Access Compliance Report Public Rights-of-Way (Curb Ramps)

Main Street: LEAFWOOD_LN Cross Street: YORBA_ST Location: NE

ADA ID: RPAT220222165056 Ramp Type: Type 1 - Perpendicular Initial Pass/Fail: Fail Overall Compliance: No Severity Score: 2

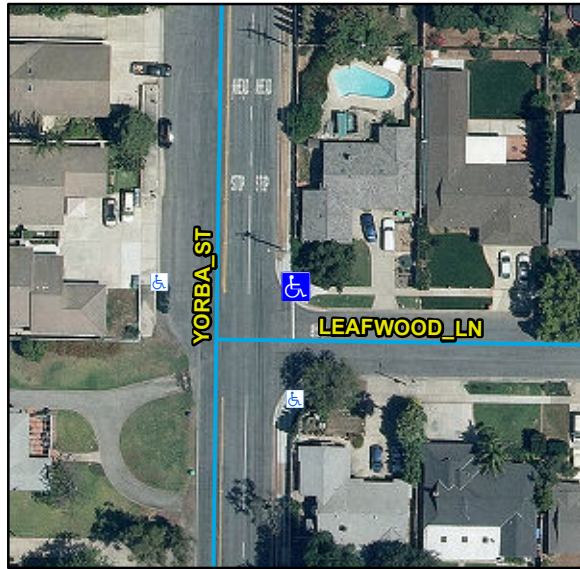
Compliance	Description	Data	Compliance	Description	Data
N/A	Ramp Length (in)	44	N/A	Flare Type LT	
Yes	Ramp Width (in)	60			N/A
Yes	Ramp Run Slope (%)	6.8	N/A	Flare Slope LT (%)	N/A
No	Ramp Cross Slope (%)	2.6	N/A	Flare Traversable LT	N/A
N/A	Landing Present	N/A	N/A	Flare Type RT	
N/A	Landing Length (in)	N/A			N/A
N/A	Landing Width (in)	N/A	N/A	Flare Slope RT (%)	N/A
N/A	Landing Run Slope (%)	N/A	N/A	Flare Traversable RT	N/A
N/A	Landing Cross Slope (%)	N/A	N/A	DWS Provided	N/A
N/A	Landing Movement Obstructed?	N/A	N/A	DWS Contrast	N/A
	Landing Movement Type	N/A	N/A	DWS Length (in)	N/A
N/A	Landing Shared	N/A	N/A	DWS Full Width	N/A
N/A	Clear Space	N/A	N/A	DWS Offset Left (in)	N/A
N/A	Clear Space To Crosswalk (in)	N/A	N/A	DWS Offset Right (in)	N/A
N/A	Marked Crosswalk 1	No	N/A	Marked Crosswalk 2	N/A
	Crossing 1 Direction	S		Crossing 2 Direction	N/A
	Marked Crosswalk 1 Width (in)	N/A		Marked Crosswalk 2 Width (in)	N/A

N/A	Ramp Inside Crosswalk 1	N/A	Yes	Ramp Inside Crosswalk 2	N/A
	Crossing 1 Slope (%)	0.3		Crossing 2 Slope (%)	N/A
	Crossing 1 Cross Slope (%)	5.1		Crossing 2 Cross Slope (%)	N/A
N/A	Gutter Ponding	N/A	No	Curb Slope	6.3
Yes	Gutter Lip Height (in)	0		Road Run Slope (%)	N/A
N/A	Gutter Run Slope (%)	N/A		Road Cross Slope (%)	N/A
N/A	Gutter Cross Slope (%)	N/A			
Yes	Overall Surface Condition: Acceptable		Yes	Perp Joint Present	Yes
	Cross Gutter Present?	No		Spandrel Present?	No
	Replace Cross Gutter?	N/A		Replace Spandrel?	N/A

Remove & Replace Entire Ramp.

R304.2.2, R304.5.3, STD 1115
